Product Change Notification / ALAN-10TGOX439

CCB 4967 Final Notice: Qualification of MTAI as an additional final test site for selected SST25VF512A device family available in 8L TDFN (6x5x0.8mm) package.

**CCB 4967**  
**Pre and Post Change Summary**  
**PCN# ALAN-10TGOX439**

# Pin 1 Orientation

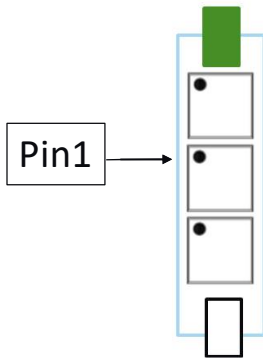
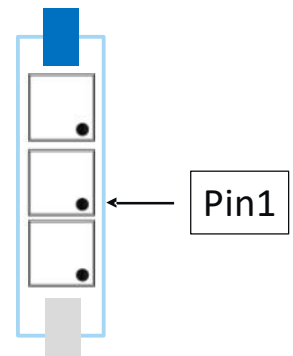
Media	Pin1 Side	Opposite Side
TUBE	Colored stopper	White stopper

Media	Pin1 Side	Opposite Side
TUBE	GREY	BLUE

# Tube

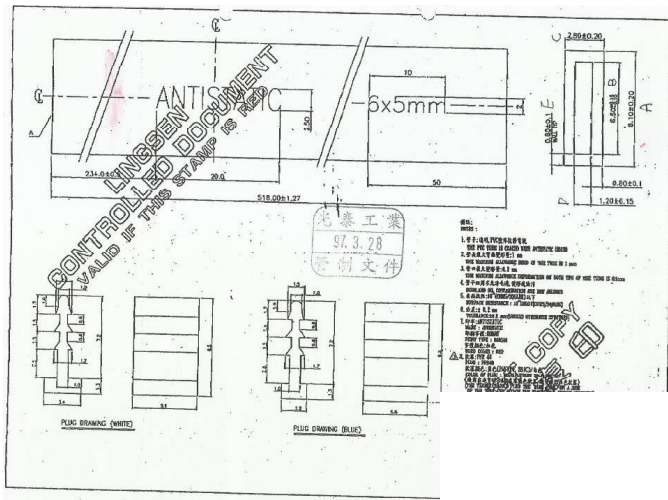
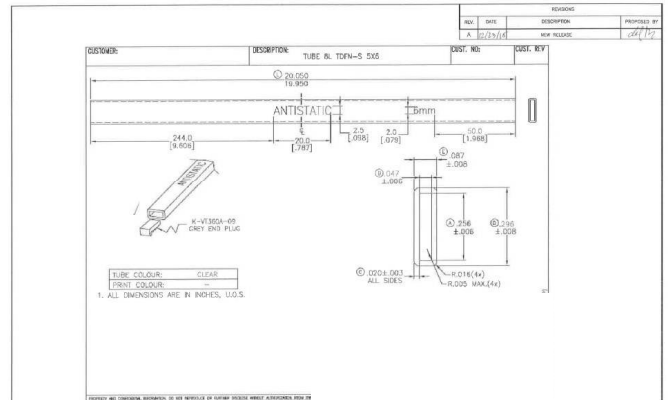
Length	Color
20.393 inch	Clear

Length	Color
20.050 inch	Clear

# Cover Tape

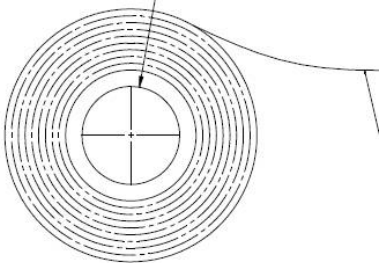
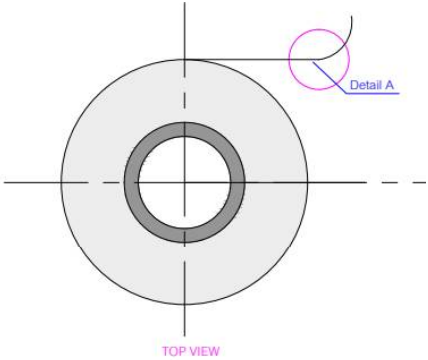
Plant	Width W (mm.)	Thickness T (mm.)	Color	Sealing Methodology
KYE	13.3	0.048	Transparent	Heat Seal
MTAI	13.3	0.050	Clear	Heat Seal

# Plastic Reel

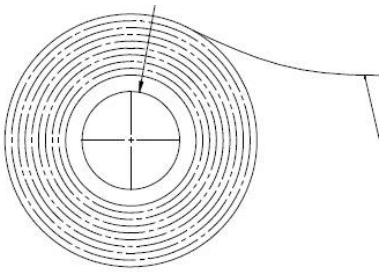
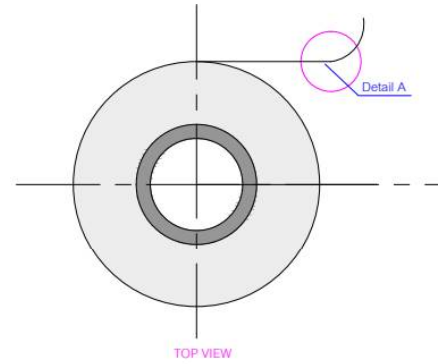
Plant	Reel Diameter (mm.)	Reel Hub Size (mm)	Reel Width Max (mm.)	Color
KYE	330	100	22.20	Regrind Blue
MTAI	330	102	22.40	Dark Blue
